P802.1Qdy - RSTP/MSTP YANG – Reusability across SDOs  
Murugan Balraj (Nokia)  
[murugan.balraj@nokia.com](mailto:murugan.balraj@nokia.com)

This presentation

# The problem (RSTP)

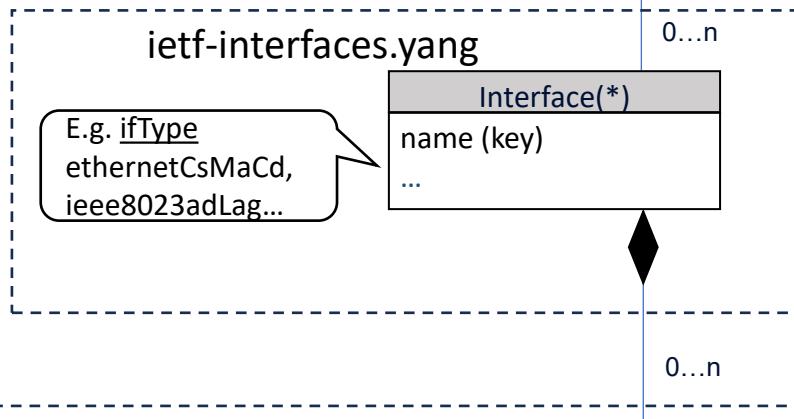
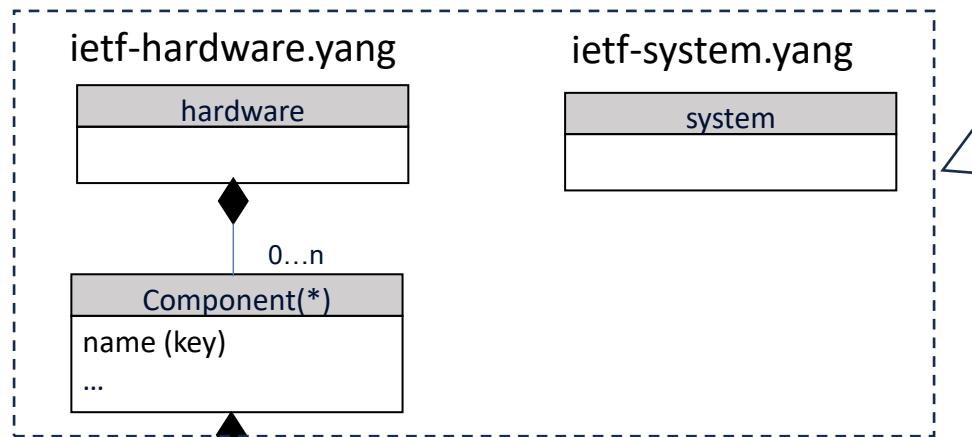
The “augments” clause present in the YANG module cannot be overridden and this makes it impossible for other SDOs to use this YANG module since they may not have the notion of Bridge / Component

- Split the YANG module into two modules. The Base YANG module would contain the protocol specific YANG definitions and an IEEE 802.1 specific module would augment this base module and contain the “augment” clauses.
- Other SDOs like BBF could then use just the Base YANG module.

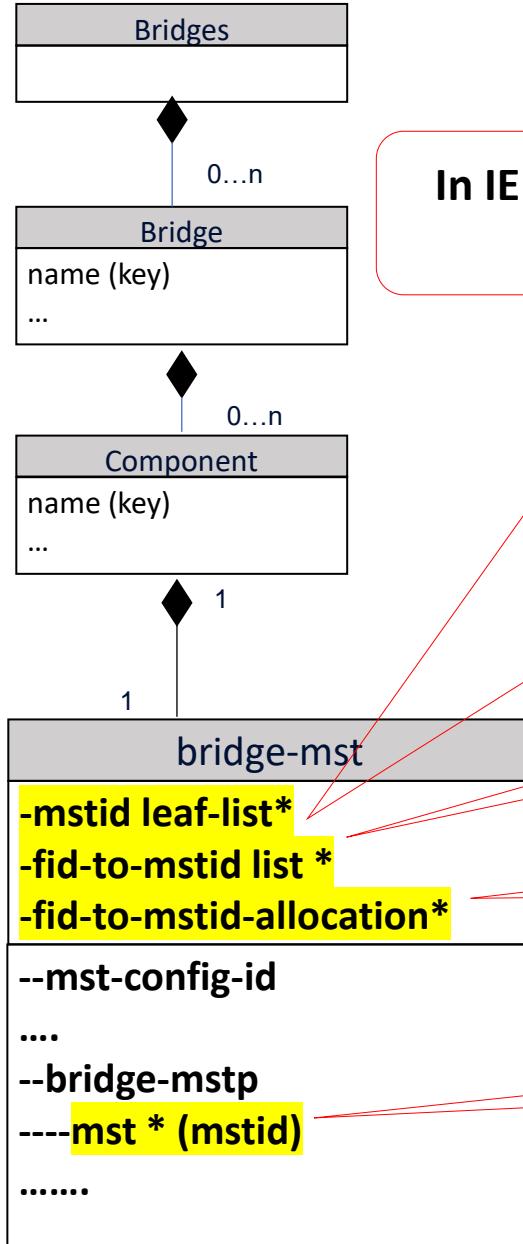
In IEEE P802.1Q-2022-REV , a container “bridge-mst” is defined with an object “mstid” which is a leaflist (/bridges/bridge/component/bridge-mst/mstid)

In IEEE P802.1Q-2022-REV, a container “bridge-mst” is defined which has a list “fid-to-mstid” that also has an object mstid /bridges/bridge/component/bridge-mst/fid-to-mstid/mstid

In IEEE P802.1Q-2022-REV, a container “bridge-mst” is defined which has a list “fid-to-mstid-allocation” that also has an object mstid /bridges/bridge/component/bridge-mst/fid-to-mstid-allocation/mstid

In P802.1Qdy, another list for the mst instance is introduced (/bridges/bridge/component/bridge-mst/bridge-mstp/mst)

Since all the above objects refer to the same MST Instance ID, there could be a different set of values in each of these lists

- Would it be acceptable to remove the “mstid” leaf-list from IEEE Std 802.1Q ?
- The list /bridges/bridge/component/bridge-mst/bridge-mstp/mst proposed as part of P802.1Qdy should be sufficient to configure the MST instances. This list would be the main list/configuration for the set of MST instances in each Bridge component.
- If there is a need to refer/specify the “mstid” anywhere else in the YANG tree, a “leafref” type could be used.
- E.g. In the two lists “fid-to-mstid” and “fid-to-mstid-allocation”, the definition of “leaf mstid” could be changed from “type dot1qtypes:mstid-type” to “type leafref”.
- Also, these two lists would need to be moved to the newly proposed IEEE 802.1 specific YANG module “ieee802-dot1q-mstp-bridge” (since these would need to be augmented to Bridge-component).

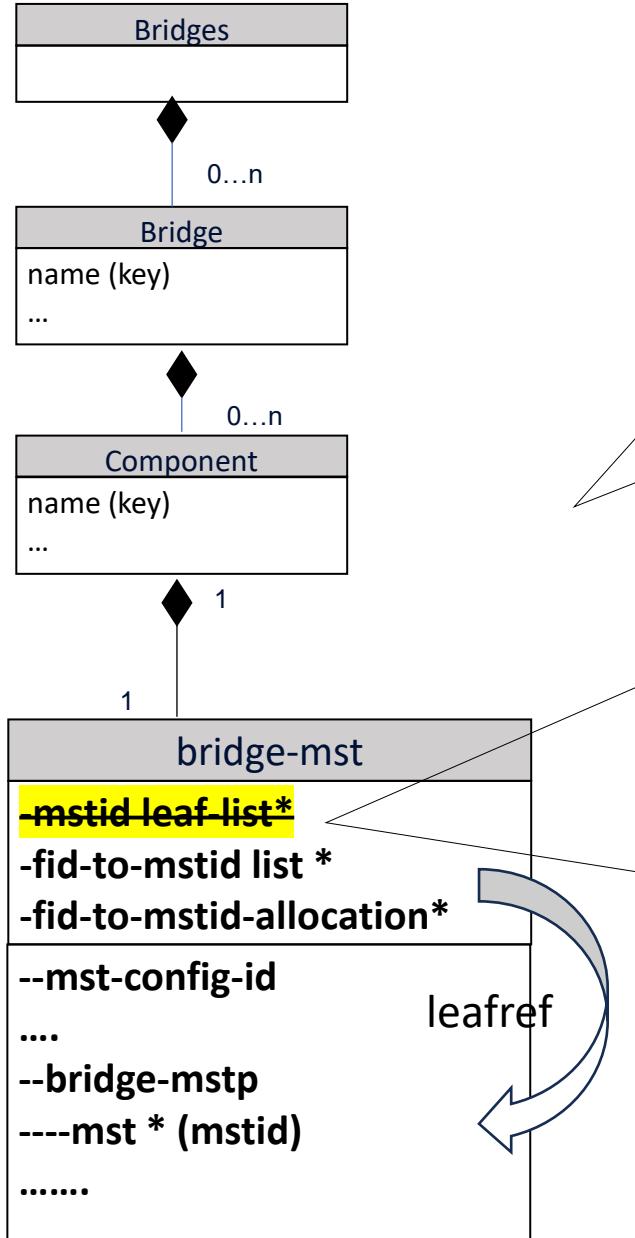
XPATHS	Example configured values (mstid)
(leaf-list) /bridges/bridge/component/bridge-mst/mstid	{100, 101, 102, 103}
(list) /bridges/bridge/component/bridge-mst/fid-to-mstid {fid, mstid}	{1, 100}, {2, 109}, {3, 103}
(list) /bridges/bridge/component/bridge-mst/fid-to-mstid-allocation {fids, mstid}	{500, 110}, {501, 100}, {502, 111}
(list) /bridges/bridge/component/bridge-mst/bridge-mstp/mst {mstid, config/state parameters}	{100, 200}
Highlighted in RED are misconfigurations w.r.t /bridges/bridge/component/bridge-mst/mstid leaf-list configuration

Avoiding inconsistent configuration and/or redundant data may require modifying the YANG objects specified in IEEE Std 802.1Q-2022 under “/bridges/bridge/component/bridge-mst”.

Ref : [802-1Qdy-d2-0.pdf](#),  
Page 19

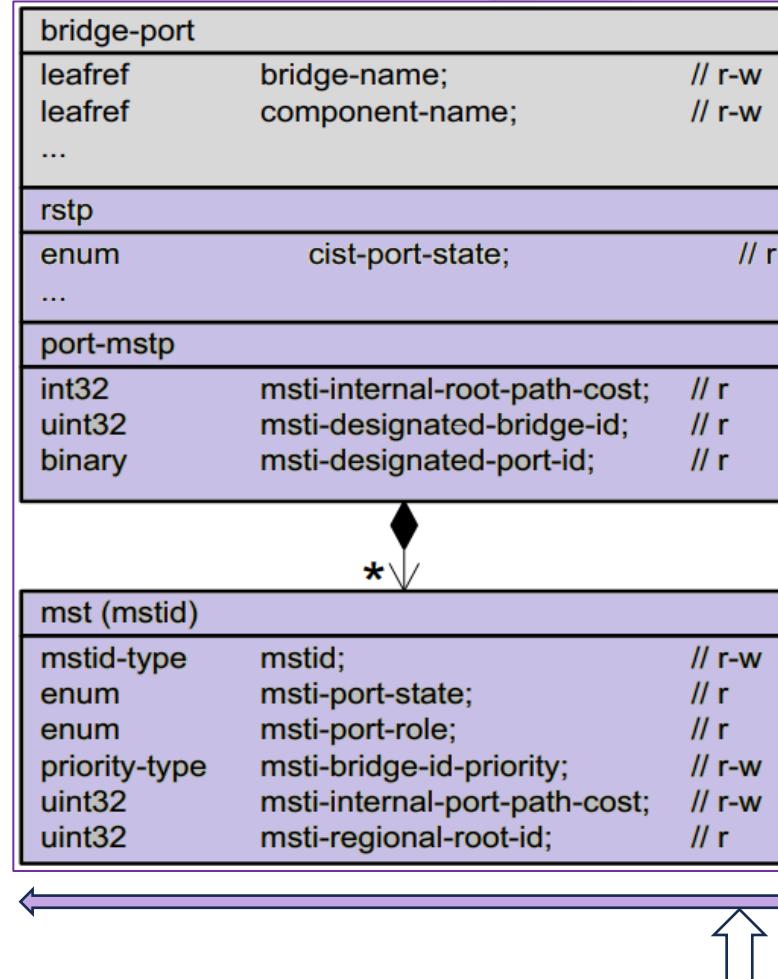
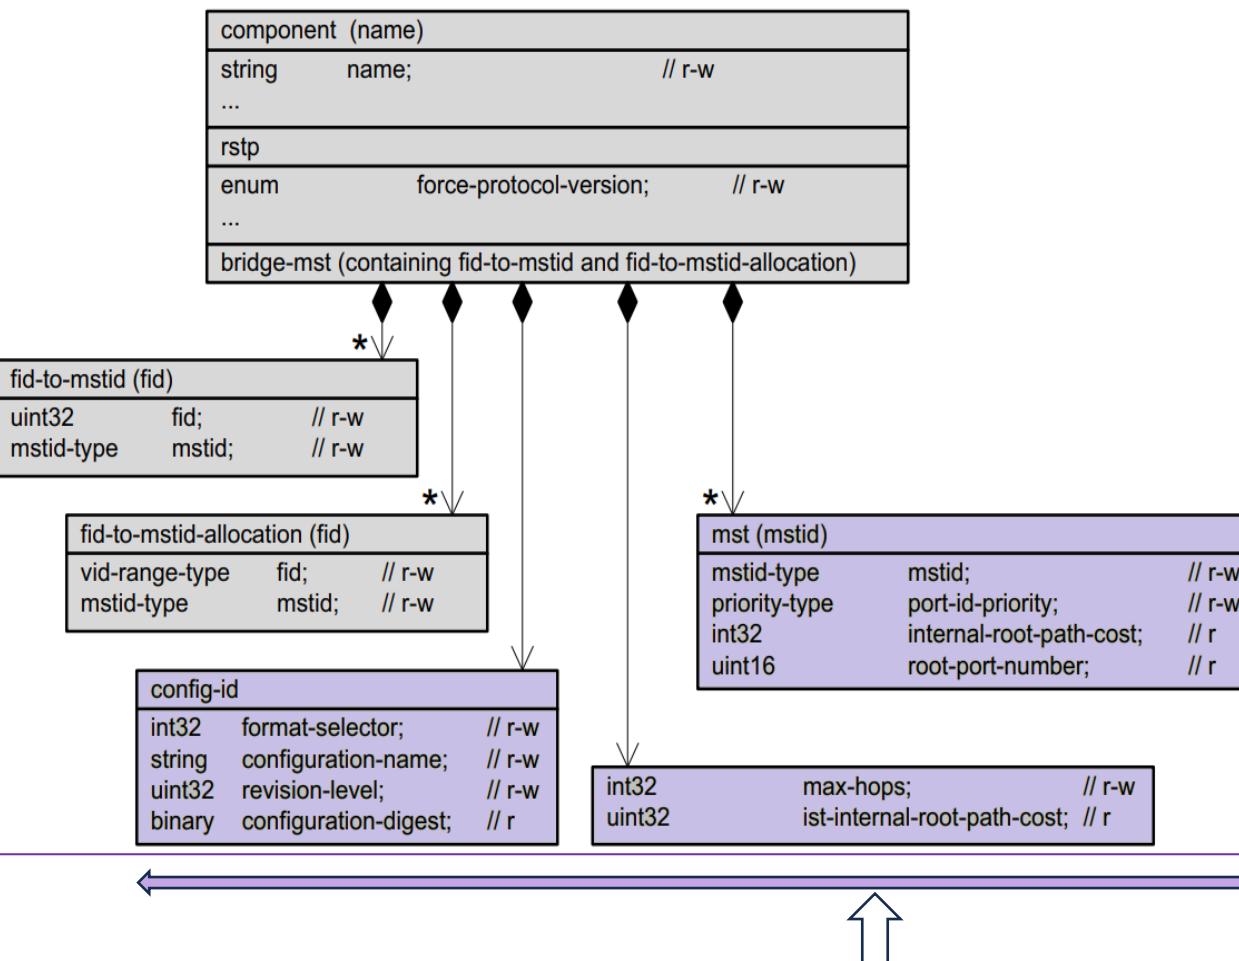
These RSTP protocol specific configuration and state data directly augment "/bridges/bridge/component".

**A non-IEEE 802.1 device cannot import this YANG module due to the direct augmentation.**

These RSTP protocol specific interface configuration and state data directly augment "/interface/interface/bridge-port".

**A non-IEEE 802.1 device cannot import this YANG module due to the direct augmentation.**
